OWNER:  شرکت سست و سویی توستر ایرانیاان (سهایی نیاان)	BUSHEHR PETROCHEMICAL COMPANY MEG PLANT						EPC CONTRACTOR:  Chagalesh-Enerchimi-Steam Joint Venture BUPC-MEG PLANT PROJECT		
	MC :  شرکت سست و سویی توستر ایرانیاان (سهایی نیاان)	HAZOP / SIL REPORT							
		Project	Area	Phase	Unit	Dis.	Doc.	Seq.	Contract No : 52-98/445
Owner Document Number: 17811-78	BU	20	VD	303	QC	REP	0105	Rev.: 01	Page 1 of 48

HAZOP / SIL REPORT

**BUPC MEG Plant HAZOP & SIL Report –
N2 and Air Compressor
Detailed Design**

Client Report No: BUPC-17811-OO-0703

DRAWING TITLE: 17811-03 P&ID FOR NITROGEN GAS BOOSTER

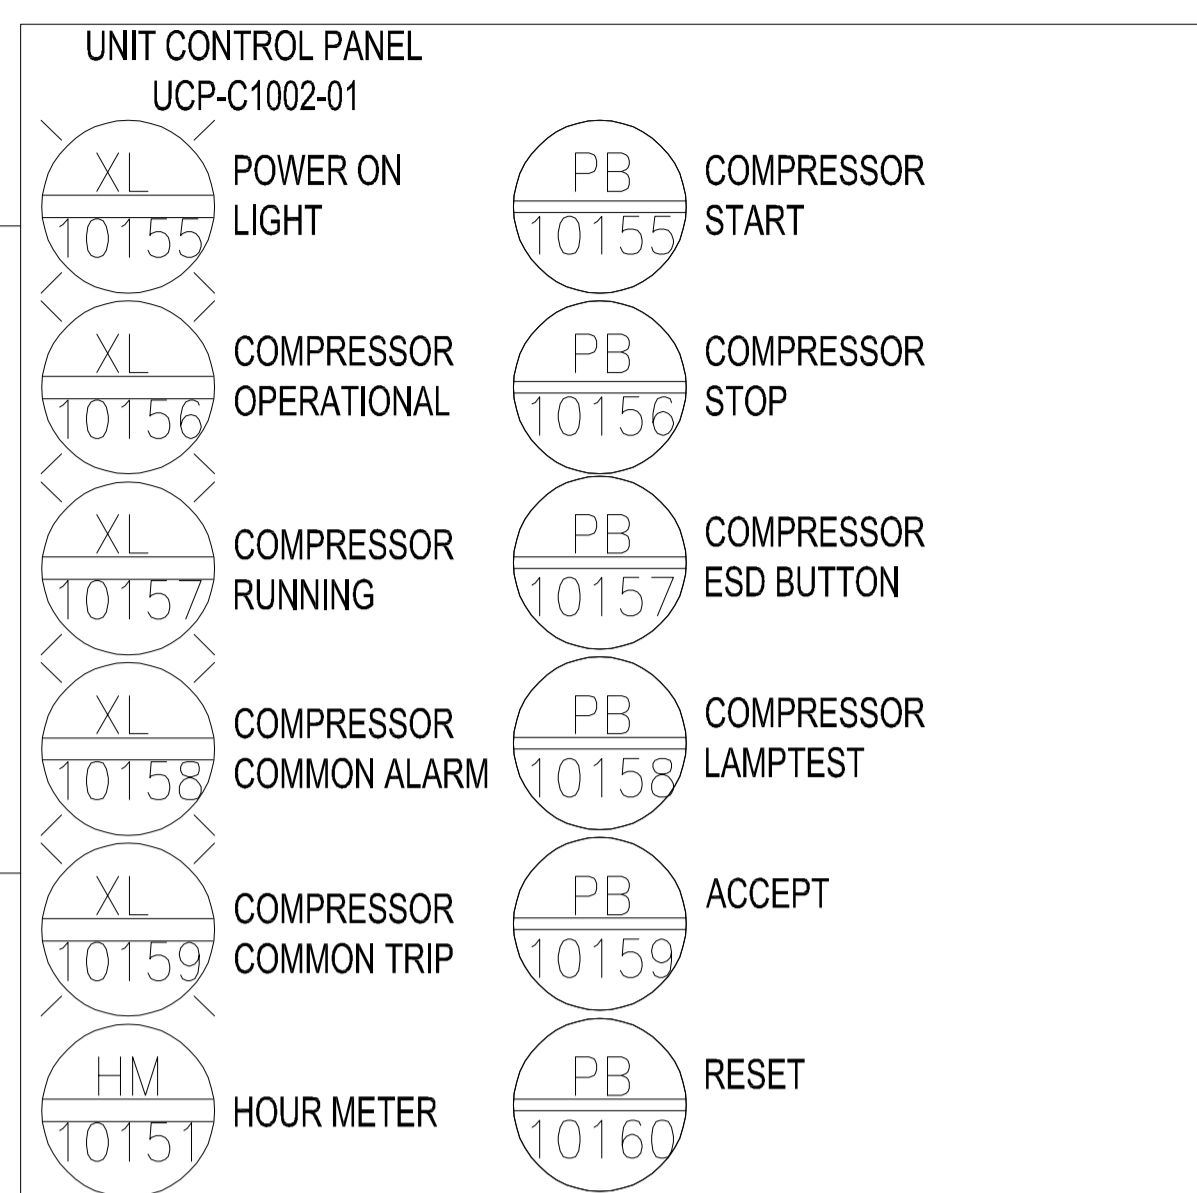
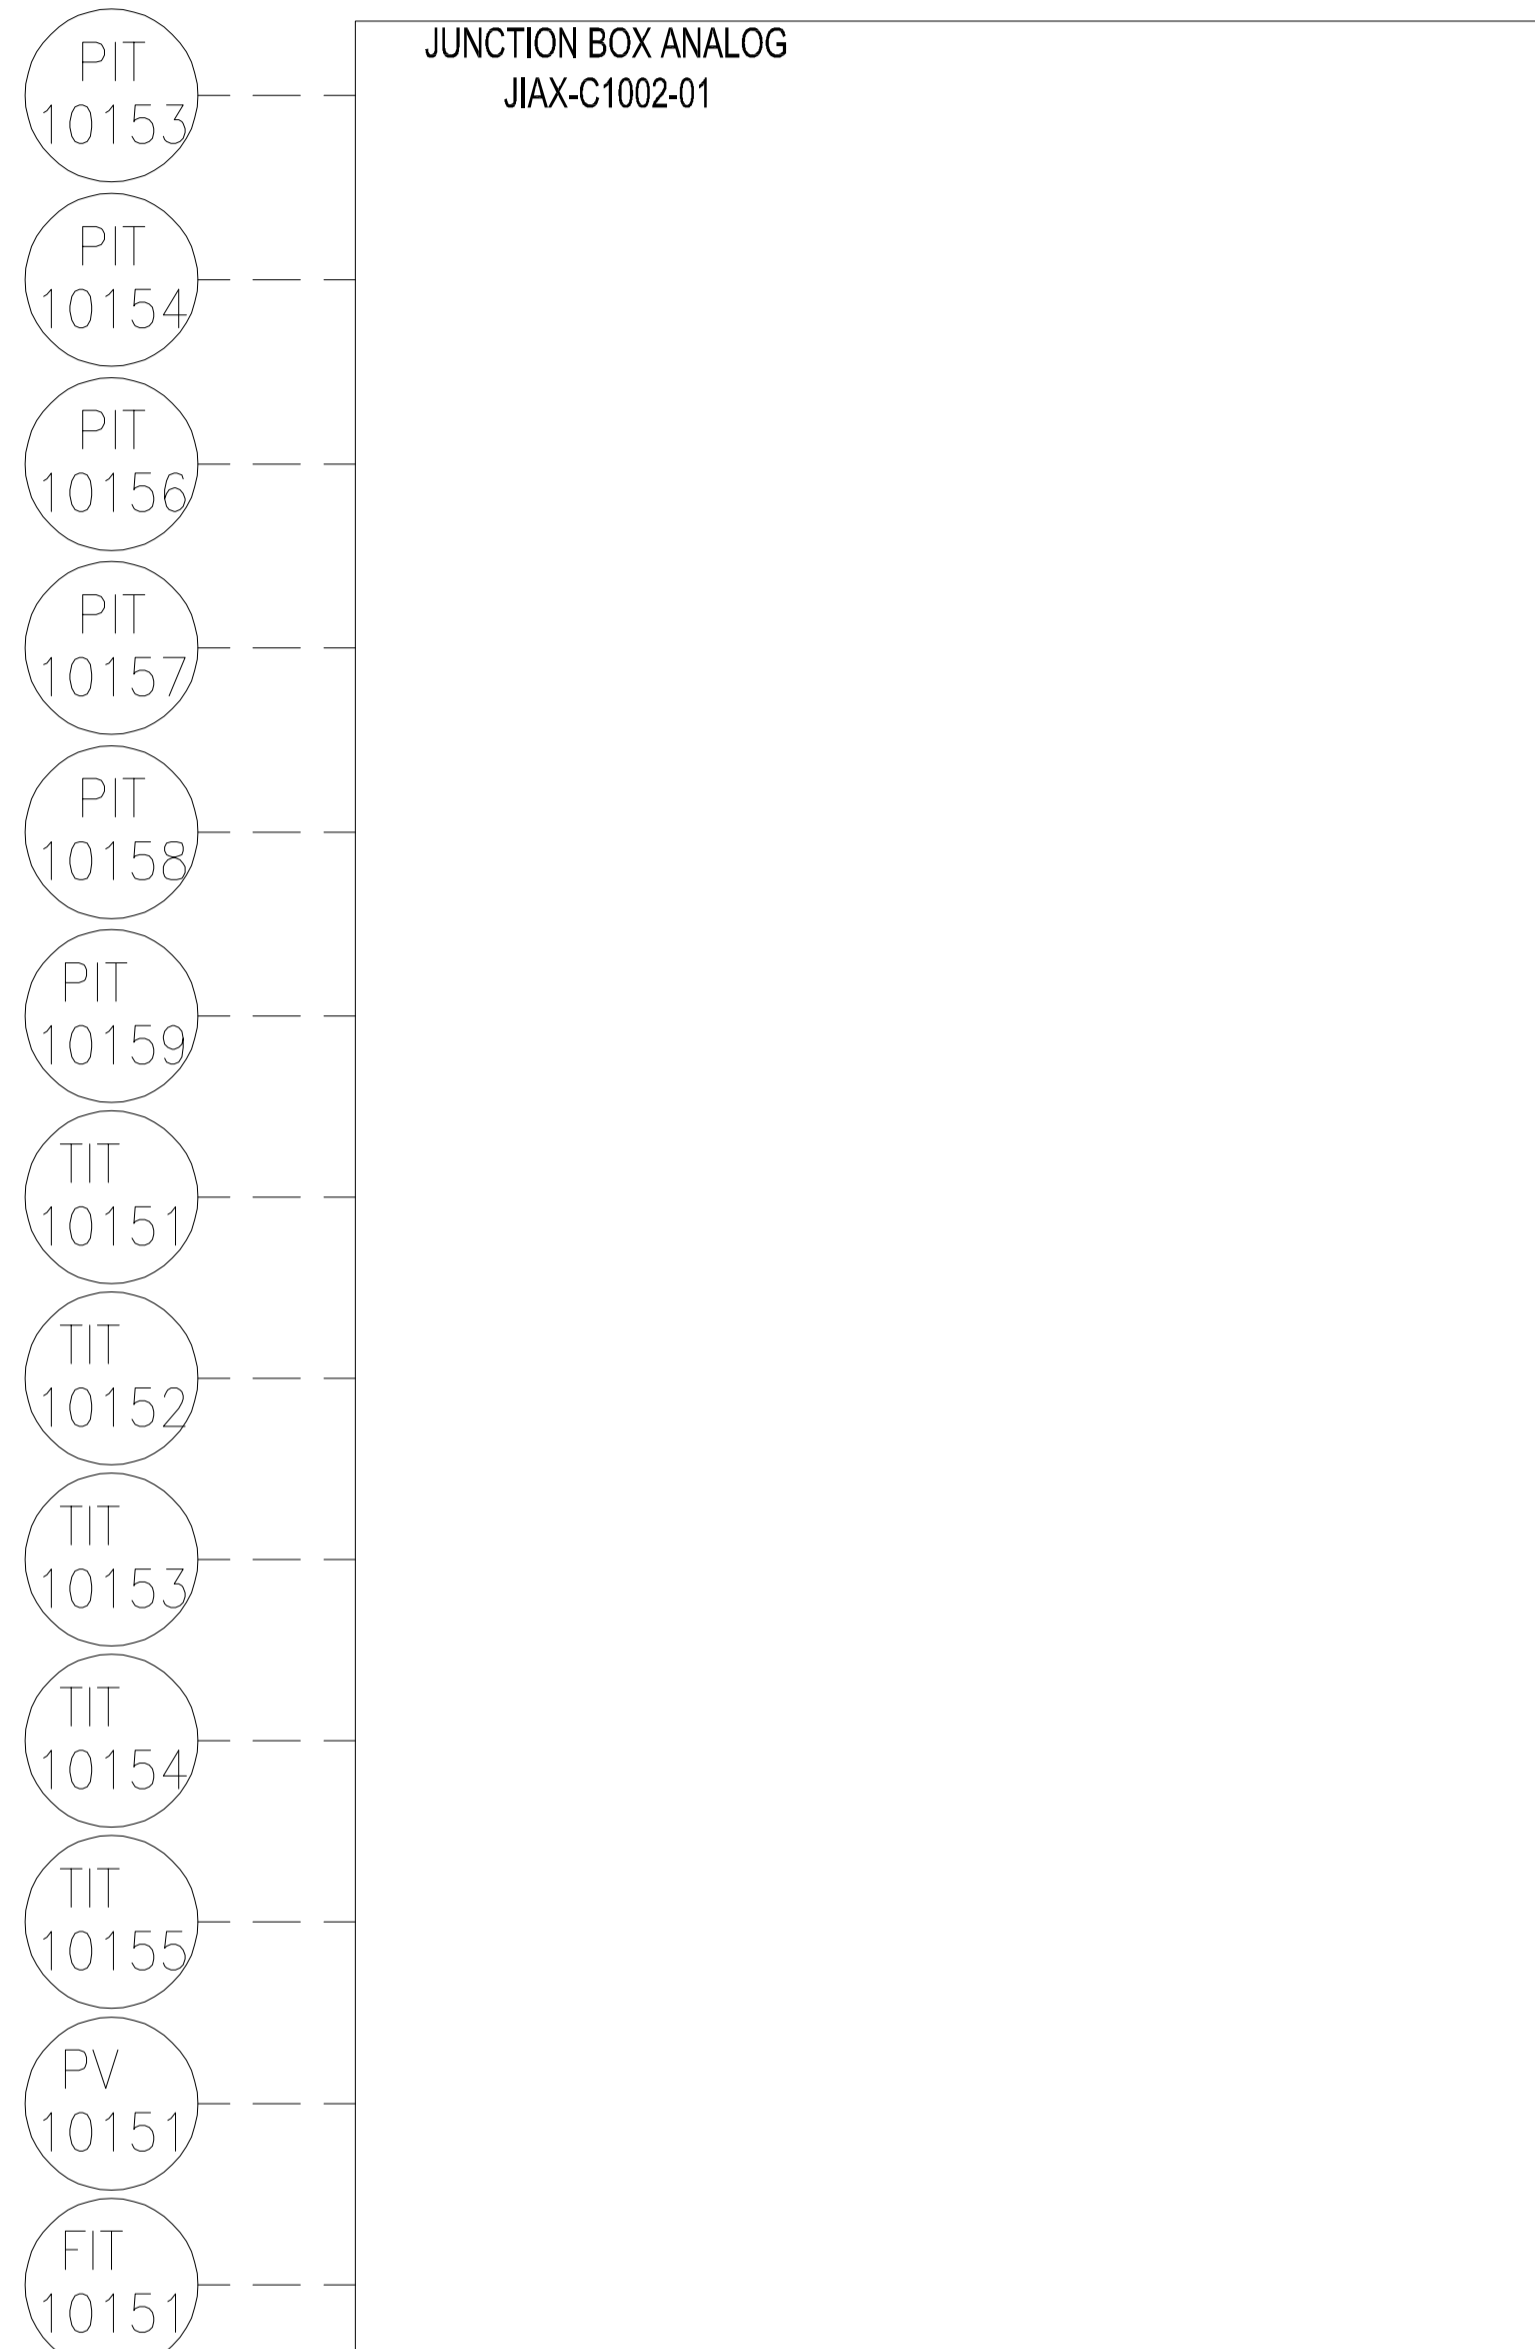
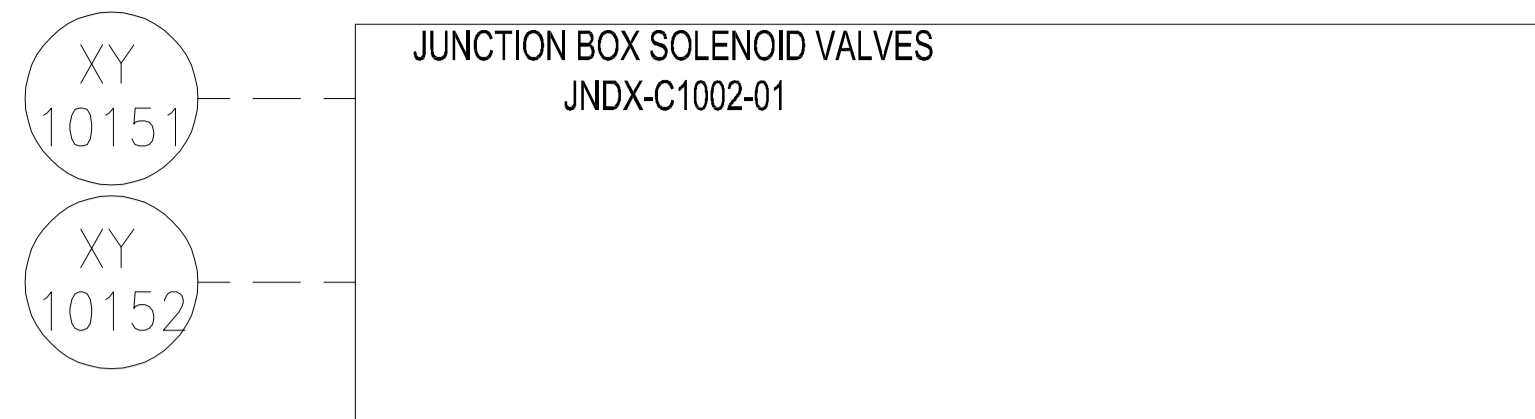
01.1.1.1	Flow	No / Not	No/Less Flow	No nitrogen supply from Plant	1. No Supply to the compressor leading to underpressure at the suction side of the compressor. Worst case is if recycle line is closed. No vacuum is expected, however the 1stage discharge pressure will decrease. Increase of temperature of the second stage exceeding the design temperature of the Compressor. Less supply to the end users. Vibrations of the axis of the compressor is possible. No loss of containment. No hazardous consequence. Asset damage (L) only 2nd stage < 5000 US\$.	L	1. PIT-10153-PALL to Trip 20-C-1002 (UCP ESD) 2. PIT-10159-PALL to Trip 20-C-1002 (UCP ESD) 3. TIT-10155-TAHH to trip 20-C-1002 (UCP ESD)	1	3	SIL 0	1. PIT-10153-PALL to Trip 20-C-1002 (UCP ESD) 2. PIT-10159-PALL to Trip 20-C-1002 (UCP ESD) 3. TIT-10155-TAHH to trip 20-C-1002 (UCP ESD)	3	No action

01.1.2.1	Flow	No / Not	No/Less Flow	Blocked Filter/Strainer in supply line (inlet)	1. No Supply to the compressor leading to underpressure at the suction side of the compressor. Worst case is if recycle line is closed. No vacuum is expected, however the 1stage discharge pressure will decrease. Increase of temperature of the second stage exceeding the design temperature of the Compressor. Less supply to the end users. Vibrations of the axis of the compressor is possible. No loss of content. No hazardous consequence. Asset damage (L) only 2nd stage < 5000 US\$.		1. PIT-10153-PALL to Trip 20-C-1002 (UCP ESD) 2. PIT-10159-PALL to Trip 20-C-1002 (UCP ESD) 3. TIT-10155-TAHH to trip 20-C-1002 (UCP ESD)	1	3	SIL 0	1. PIT-10153-PALL to Trip 20-C-1002 (UCP ESD) 2. PIT-10159-PALL to Trip 20-C-1002 (UCP ESD) 3. TIT-10155-TAHH to trip 20-C-1002 (UCP ESD)	3	No action

01.1.3.1	Flow	No / Not	No/Less Flow	Motor or V-belt Drive Failure Compressor 20-C-1002-M	1. No Supply to the end user. Discharge pressure of the Compressor will decrease. No supply to the end users. No hazardous consequence. No asset consequences		1. PIT-10159-PALL to Trip 20-C-1002 (UCP ESD) 2. PIT-10154-PALL to Trip 20-C-1002 (UCP ESD) (lube oil pressure low will stop the compressor)

01.1.4.1	Flow	No / Not	No/Less Flow	Mechanical Failure 1st stage Compressor 20-C-1002	1. Worst case is piston failure. No Supply to the end user. Loss of containment is possible. Maximum release < 0.2 kg/h (707 kg/h /) No suffocation to people is expected (open area, 4 sides open). Compressor may catch fire, damage of compressor. Hurting people is possible. Severity S=S2; S2 is equal to C A. Asset damage (L) is ca. 50 k. US\$ L=S1; Most severe is people risk. Note: Regular maintenance will reduce this risk.	S	1. PIT-10159-PALL to Trip 20-C-1002 (UCP ESD) 2. VT-10151-VAHH to Trip 20-C-1002 (UCP ESD)	2	3	SIL 1	1. PIT-10159-PALL to Trip 20-C-1002 (UCP ESD) 2. VT-10151-VAHH to Trip 20-C-1002 (UCP ESD) SIL1 SIF in SIS	2	No action

01.1.5.1	Flow	No / Not	No/Less Flow	Partial Blockage inside the shell of the Intercooler 20-AEC-1002-1 Gas side (Gas is going through the shell)	1. Increased pressure drop over the intercooler and increase of temperature in the outlet of the intercooler and the inlet of the 2nd stage. Exceeding of the design temperature in the discharge of the 2nd stage of the compressor. No loss of containment. No hazardous consequence. Asset damage (L) only 2nd stage < 5000 US\$. IEF=0.01	L	1. PIT-10159-PALL to Trip 20-C-1002 (UCP ESD) 2. TIT-10155-TAHH to trip 20-C-1002 (UCP ESD) 3. TIT-10154-TAH to trip 20-C-1002 by operator	1	2	No action		3	No action

01.1.6.1	Flow	No / Not	No/Less Flow	Mechanical Failure 2nd stage Compressor 20-C-1002	1. Worst case is piston failure. No Supply to the end user. Loss of containment is possible. Maximum release < 0.2 kg/h (707 kg/h /) No suffication to people is expected (open area, 4 sides open). Compressor may catch fire, damage of compressor. Hurting people is possible. Severity S=S2 S2 is equal to C A. Asset damage (L) is ca. 50 k. US\$ S=S1; Most severe is people risk. Note: Regular maintenance will reduce this risk.	S	1. PIT-10159-PALL to Trip 20-C-1002 (UCP ESD) 2. VT-10151-VAHH to Trip 20-C-1002 (UCP ESD)	2	3	SIL 1	1. PIT-10159-PALL to Trip 20-C-1002 (UCP ESD) 2. VT-10151-VAHH to Trip 20-C-1002 (UCP ESD) SIL1 SIF in SIS	2	No action

01.1.7.1	Flow	No / Not	No/Less Flow	Partial Blockage of shell of the aftercooler 20-AEC-1002-2 Gas side (Gas is going through the shell)	1. Increased pressure drop over the aftercooler and increase of temperature in the outlet of the aftercooler and in the discharge of the 2nd stage of the compressor. Exceeding of the design temperature in the discharge of the 2nd stage of the compressor (upstream aftercooler). No loss of containment. No hazardous consequence. Asset damage (L) only 2nd stage < 5000 US\$. IEF=0.01. Downstream is possibly consequences for high temperature.	L	1. PIT-10159-PALL to Trip 20-C-1002 (UCP ESD) 2. TIT-10155-TAHH to trip 20-C-1002 (UCP ESD)	1	2	No action		No action	1. Ensure that high temperature discharge from the nitrogen compressor is evaluated in the Hazop of the Plant. Maximum temperature downstream should be safeguarded on 95 deg. C (based on setting of the PSV-10152).

01.1.8.1	Flow	No / Not	No/Less Flow	Blocked flow by check valves at outlet fails closed, also in case of lower pressure downstream.	1. No supply to the end user. Increased pressure and temperature in the second stage of the compressor. Flow will be recycled to the inlet. Recycle line will be designed for full flow. No consequences.		1. PIT-10159-PAHH to trip 20-C-1002 (UCP ESD) 2. PSV-10152 @ 26 bara 3. TIT-10155-TAHH to trip 20-C-1002 (UCP ESD)

01.1.9.1	Flow	No / Not	No/Less Flow	Blocked flow downstream (no take off)	1. No supply to the end user. Increased pressure and temperature in the second stage of the compressor. Flow will be recycled to the inlet. Recycle line will be designed for full flow. No consequences.		1. PIT-10159-PAHH to trip 20-C-1002 (UCP ESD) 2. PSV-10152 @ 26 bara 3. TIT-10155-TAHH to trip 20-C-1002 (UCP ESD)

01.1.10.1	Flow	No / Not	No/Less Flow	Less/No flow over recycle line by 'Fail Closed AFC PV-10151 or control failure to closed valve in case AFC should be NOT fully closed.	1. Increased pressure and temperature in the second stage of the compressor. Exceeding of the design temperature in the discharge of the 2nd stage of the compressor. No loss of containment. No hazardous consequence. Asset damage (L) only 2nd stage < 5000 US\$. IEF=0.1	L	1. PIT-10159-PAHH to trip 20-C-1002 (UCP ESD) 2. PSV-10152 @ 26 bara 3. TIT-10155-TAHH to trip 20-C-1002 (UCP ESD)	1	3	SIL 0	1. PIT-10159-PAHH to trip 20-C-1002 (UCP ESD) . 2. PSV-10152 @ 26 bara 3. TIT-10155-TAHH to trip 20-C-1002 (UCP ESD)	4	No action

01.1.11.1	Flow	No / Not	No/Less Flow	No lube oil flow by filter blockage or Pump failure to compressor	1. Overheating of the bearings in case of long term reduced flow. Asset damage (L) of the bearings of the compressor; < 5000 US\$. IEF=0.1	L	1. PIT-10154-PALL to trip 20-C-1002 (UCP ESD) .	1	3	SIL 0	1. PIT-10154-PALL to trip 20-C-1002 (UCP ESD) .	1	No action

01.2.1.1	Flow	More	More/High Flow	More flow over the recycle line by 'Fail Opened AFC PV-10151 or control failure to opened valve in case AFC should be NOT fully opened.	1. Decreased pressure and temperature in the second stage of the compressor. Less supply to the plant/ end user. No hazardous consequence; No asset consequence.		1. PIT-10159-PALL to trip 20-C-1002 (UCP ESD)

02.1.1.4	Flow	No / Not	No/Less Flow	No Cooling Water supply from Plant	Overheating of cooling water in aftercooler 20-AEC-1002-2. Exceeding of the design temperature of the tubes inside the aftercooler (95 deg C). Maximum temperatures of the cooling water (140 deg C -equal to uncooled nitrogen- can be reached. Boiling of water may start at ca. 120 deg C. Tube rupture is possible. Nitrogen induced into the cooling water and exceeding also the design pressure of the cooling water system. Loss of containment is possible. Maximum release with full rupture- 0.2 kg/s (707 kg/h /). Full rupture is not expected. No suffocation of people is expected (open area, 4 sides open). Remote suffocation risk to people is possible (safety distance is ca. 1-2 meters. Severity S=S2 (S2 is equal to C A according risk matrix) Asset damage (L) is ca. 10 k. US\$ L=S1; Most severe risk is people risk (S=S2).	S	1. TIT-10155-TAHH to Trip 20-C-1002 (UCP ESD) 2. FT-10151-FAL to Trip 20-C-1002 by operator (only 1 alarm is counting for a risk reduction) 3. PSV-10153 @3.5 barg to ground	2	3	SIL 1	1. TIT-10155-TAHH to Trip 20-C-1002 (UCP ESD) <i>SIL 1 SIF in SIS</i> 2. FT-10151-FAL to Trip 20-C-1002 by operator (only 1 alarm is counting for a risk reduction) 3. PSV-10153 @3.5 barg to ground (RRF=100)	4	No action

02.1.1.5	Flow	No / Not	No/Less Flow	No Cooling Water supply from Plant	No Cooling of Compressor 20-C-1002. Not exceeding of the design temperature (170 deg C for valves, 210 deg C for casing and internal cooling water circuit); temperature in the discharge of the 1st stage or 2nd stage of the compressor may go up ca. 170 deg C. No loss of containment. No hazardous consequence. No Asset damage (L) is expected.		1. TIT-10155-TAH to Trip 20-C-1002 (UCP ESD) 2. FT-10151-FAL to Trip 20-C-1002 (UCP ESD)
